RE: Mary River Project - Modification Request No. 7 – 2018 Upgrades at the Mine Site and Milne Port (Water Licence 2AM-MRY1325 - Amendment No. 1)

1 – INTRODUCTION

P/A NO. NB102-181/43	REF NO. NB18-00145
FIGURE 1	
REV 0

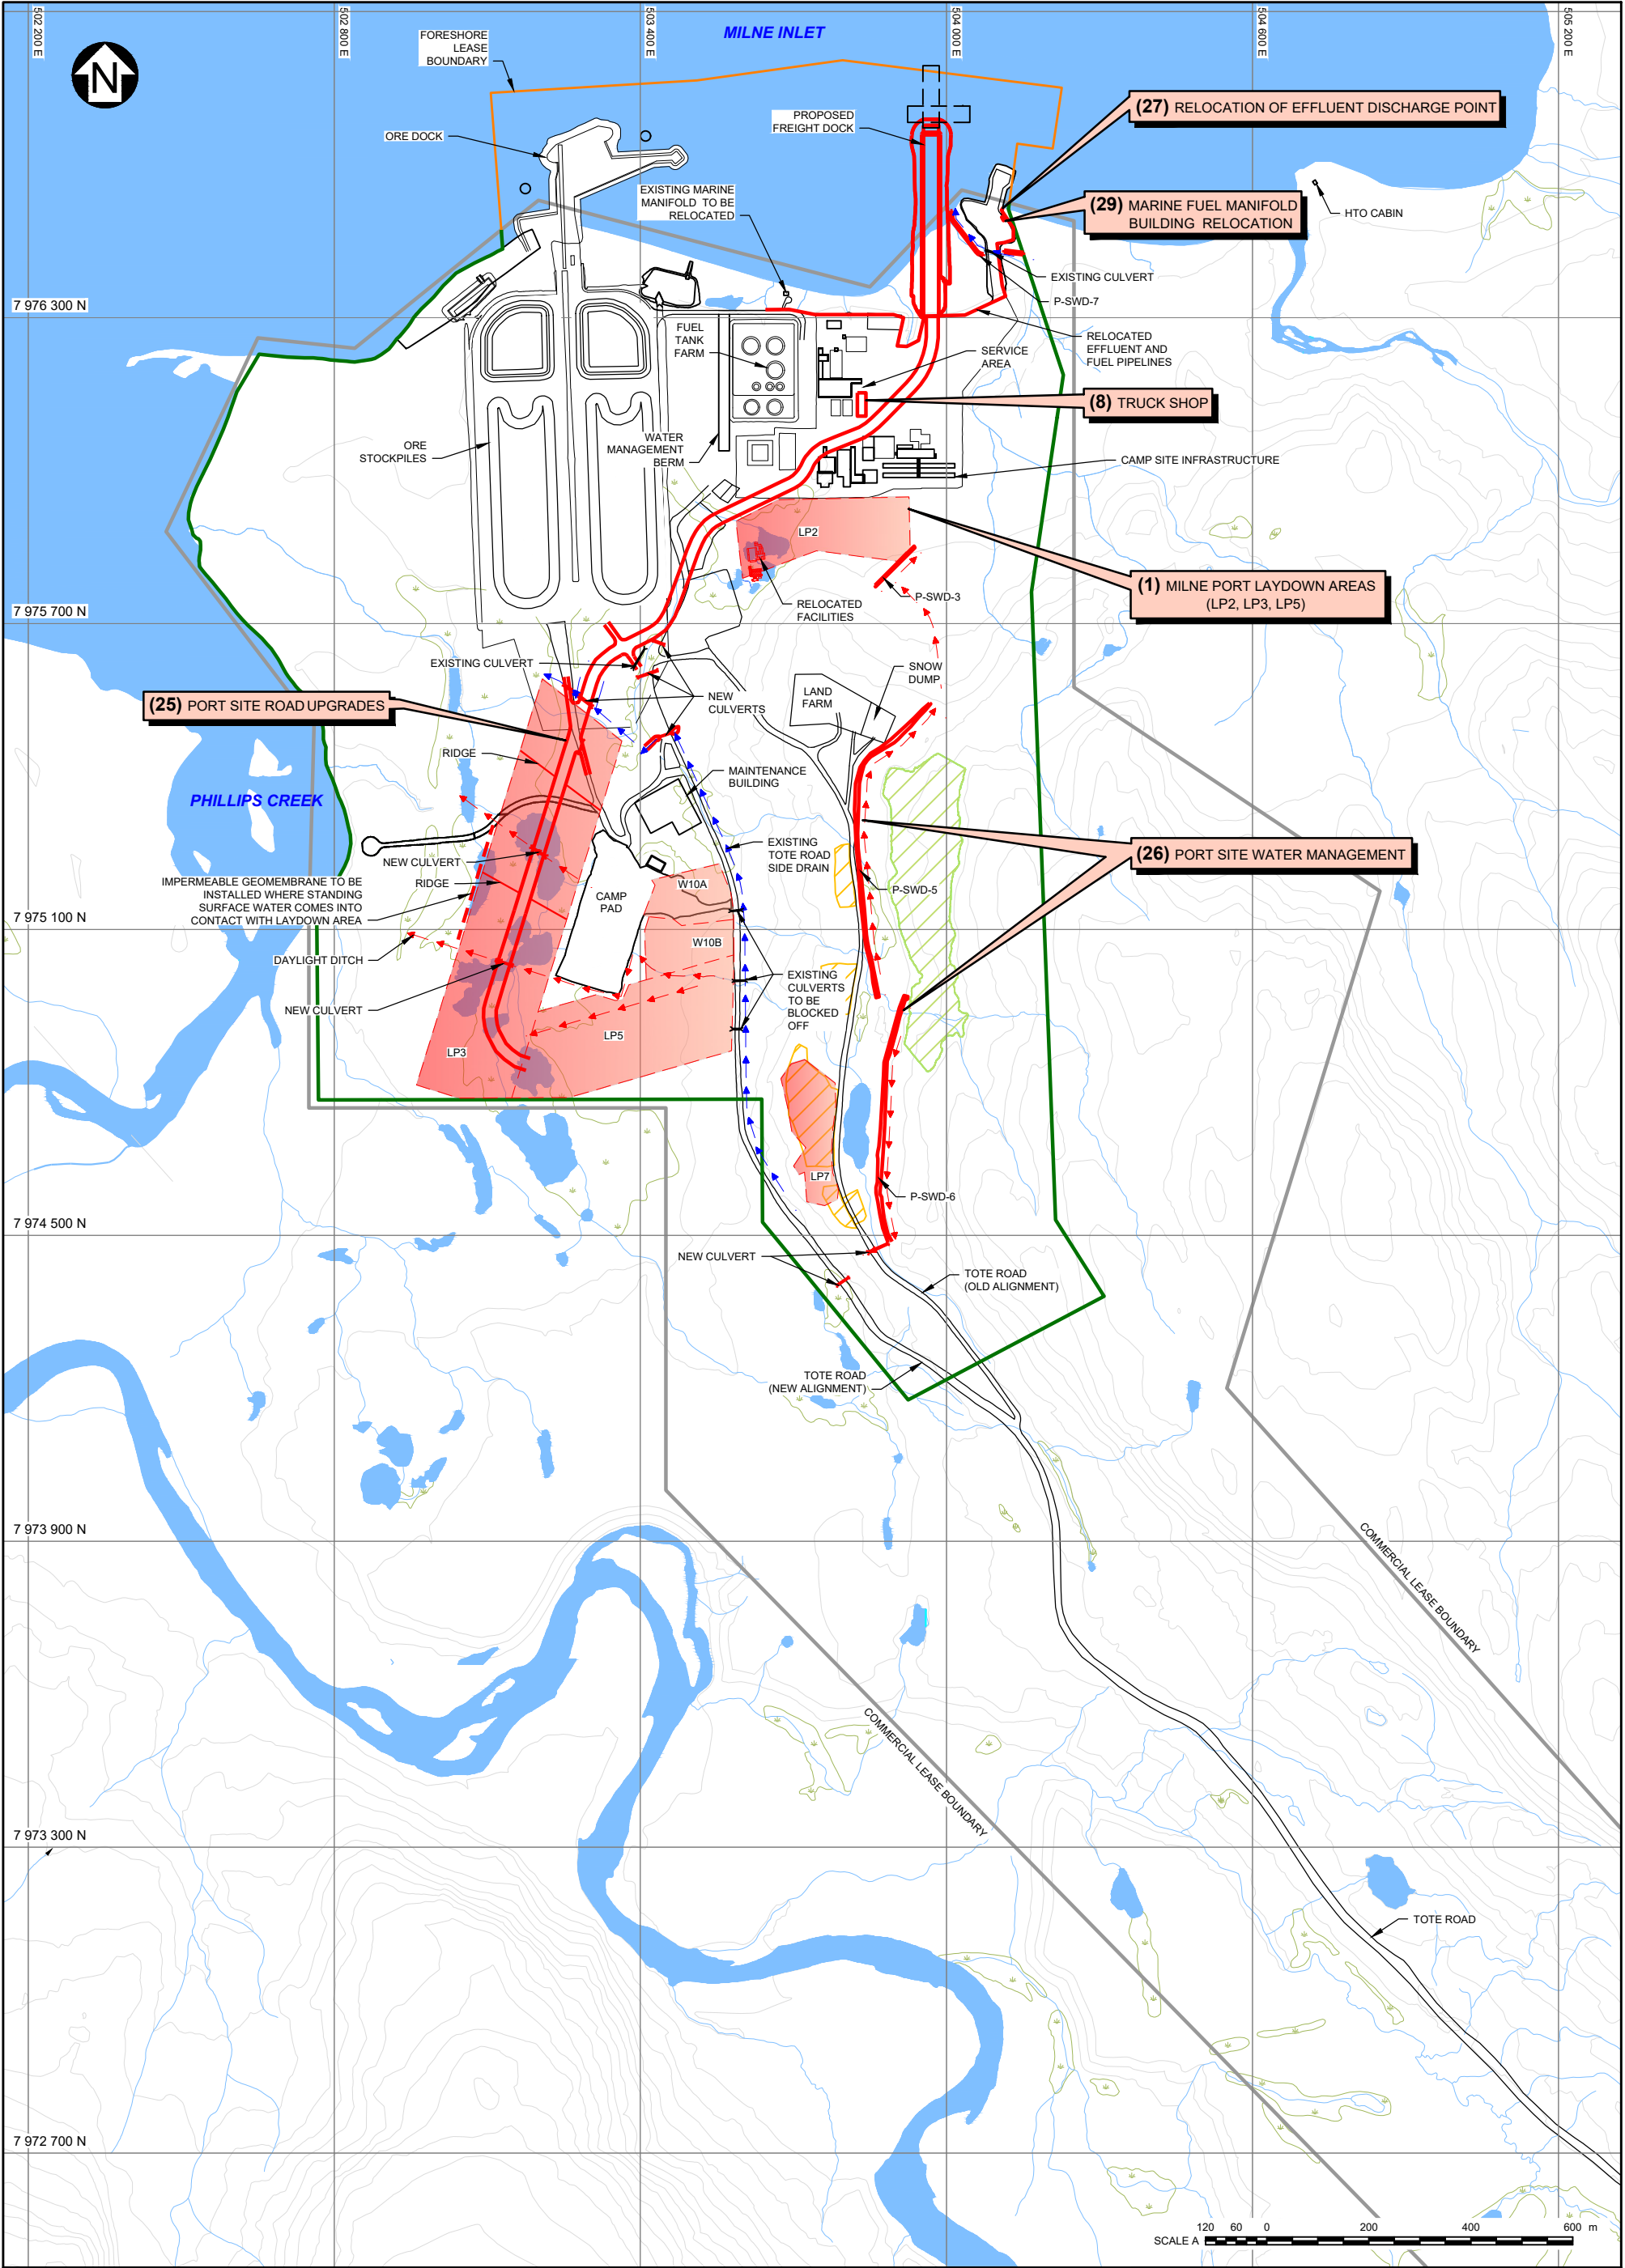
The locations of the three laydown areas are shown in Figure 1. Laydown LP2 is south of the camp site infrastructure and tank farm. Laydown areas LP3 and LP5 are located south of the ore stockpiles to the west of the site access road.

The proposed freight dock access road location is shown on Figure 1.

The key water management feature to be constructed is a diversion berm located to the east of the old Tote Road alignment (Figure 1). Diversion channels and ditching (with culverts where necessary to allow for traffic) are proposed. A portion of the water management features are in relation to the three laydown areas (LP2, LP3, and LP5) described in Section 3.1.

The effluent discharge point will be relocated to the western portion of the barge landing area at coordinates N7976518 E504044. The proposed location is shown on Figure 1.

The marine manifold building will be relocated from its current location west of the fuel tank farm to a new location at the existing barge landing (Figure 1). To facilitate the relocation minor leveling and grading will take place within the PDA.
